CITY OF ALBUQUERQUE

**RE: Midtown Self Storage Expansion
Grading and Drainage Plan
Engineer's Stamp Date 4-19-2016 (File:H17D112)**

Based upon the information received on 4-21-2016, the above-referenced Grading and Drainage Plan is approved for Grading Permit, Paving Permit and Building Permit with the following condition:

| MIDTOWN SELF STORAGE EXPANSION GRADING AND DRAINAGE PLAN | | | |

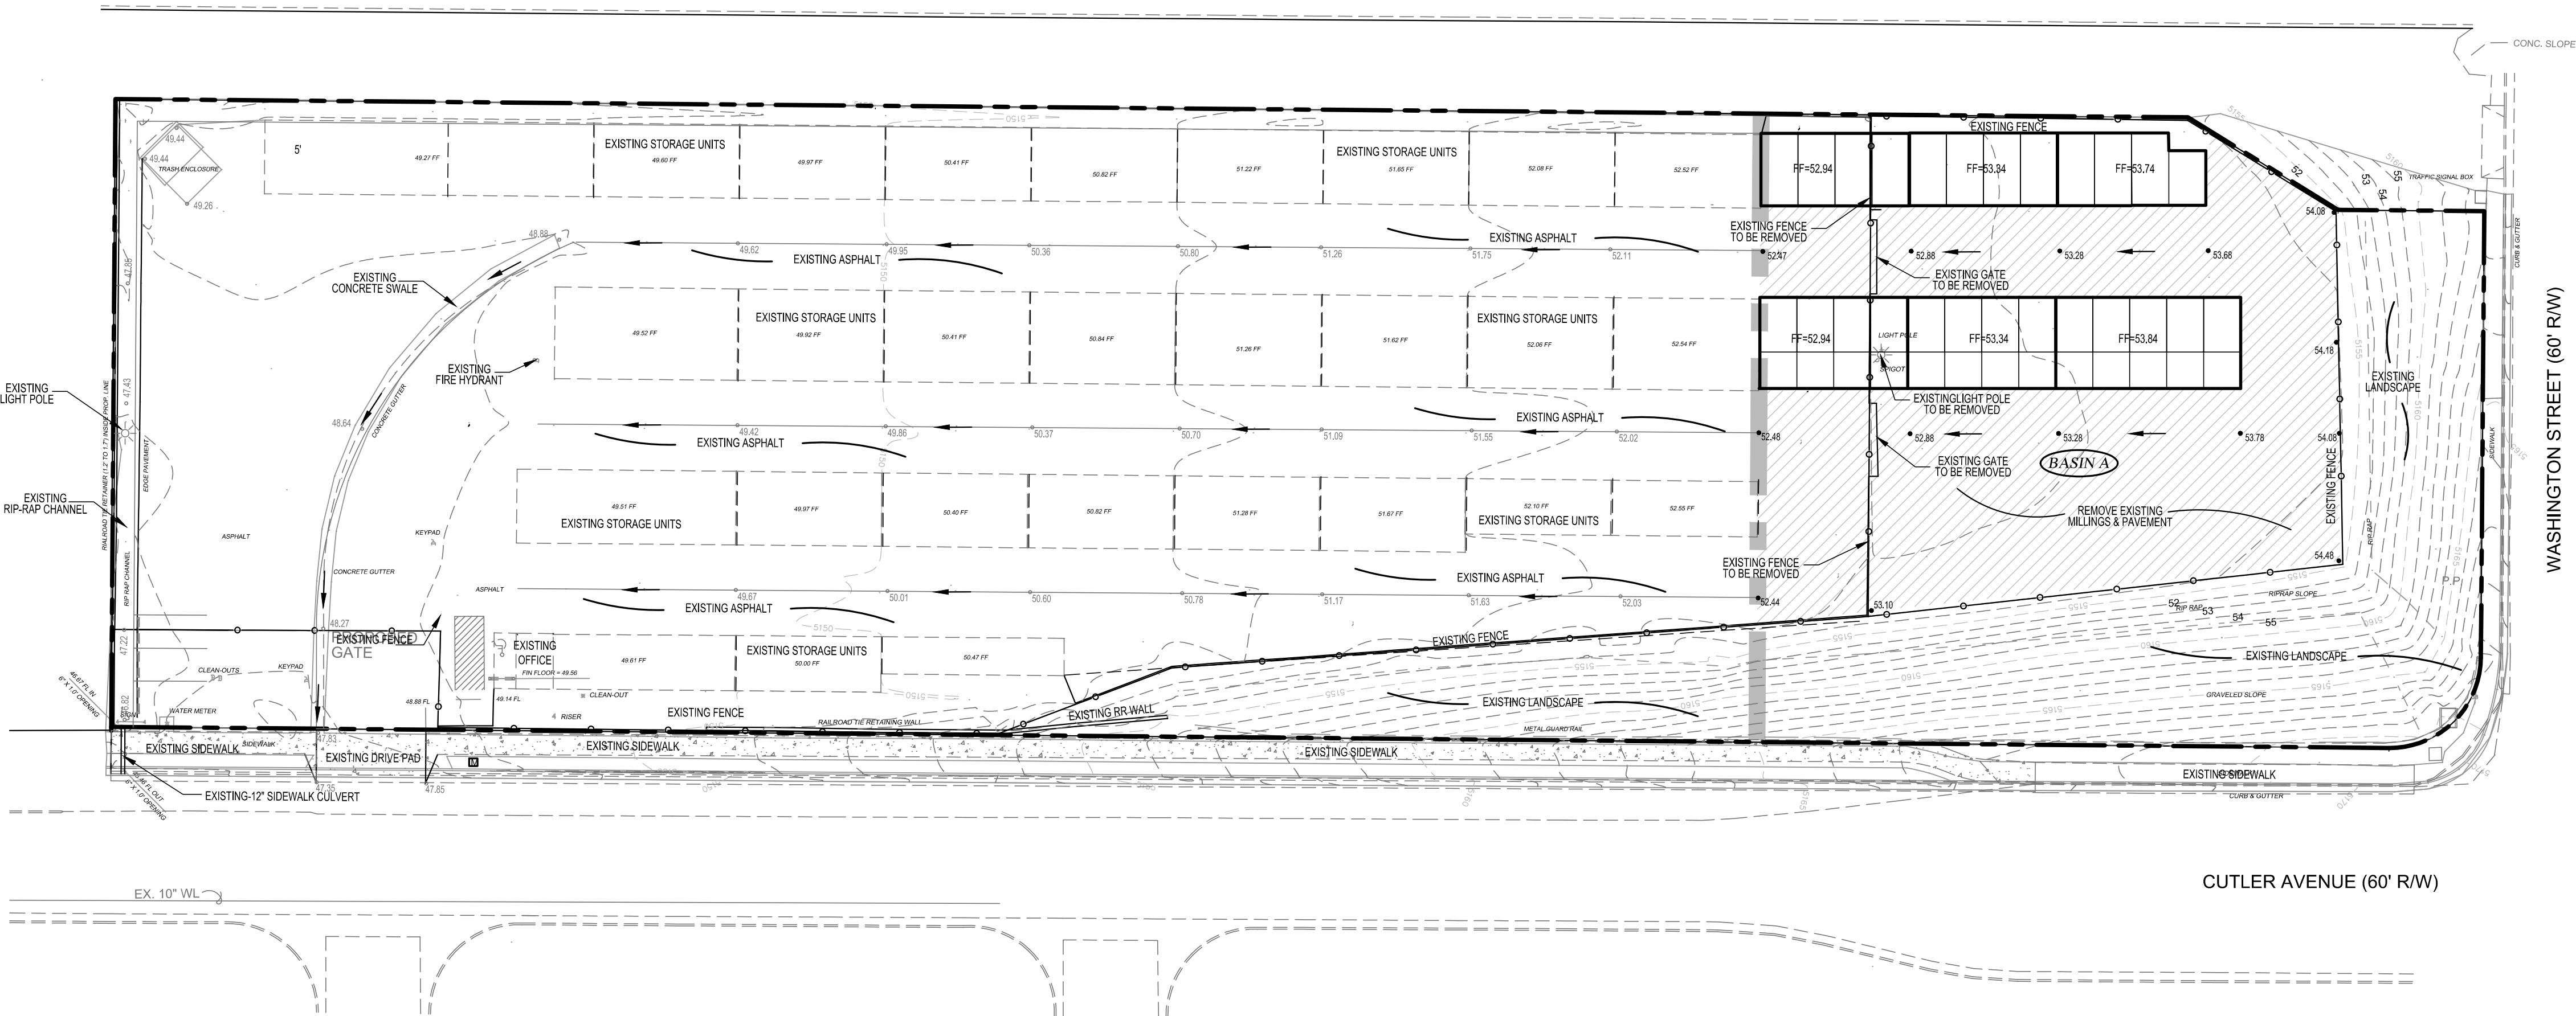
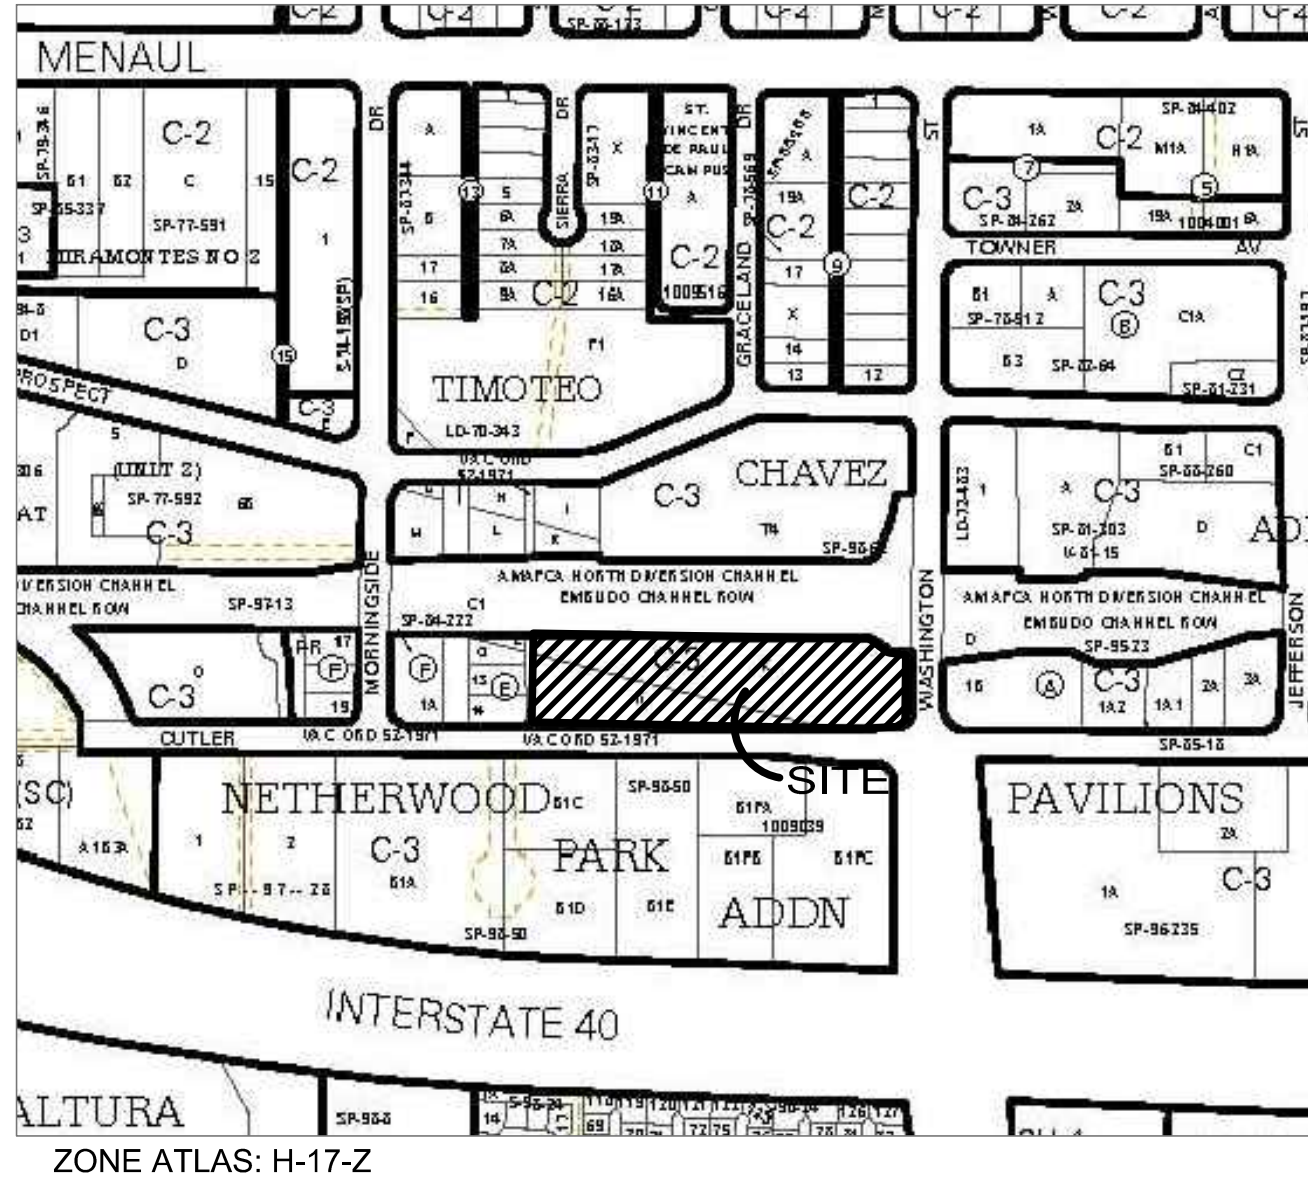
PO Box 1293 1. First flush ponding will be managed in the rip rap swale along the western edge of the property, provide dimensions and approximate volume of the pond with the Certification.
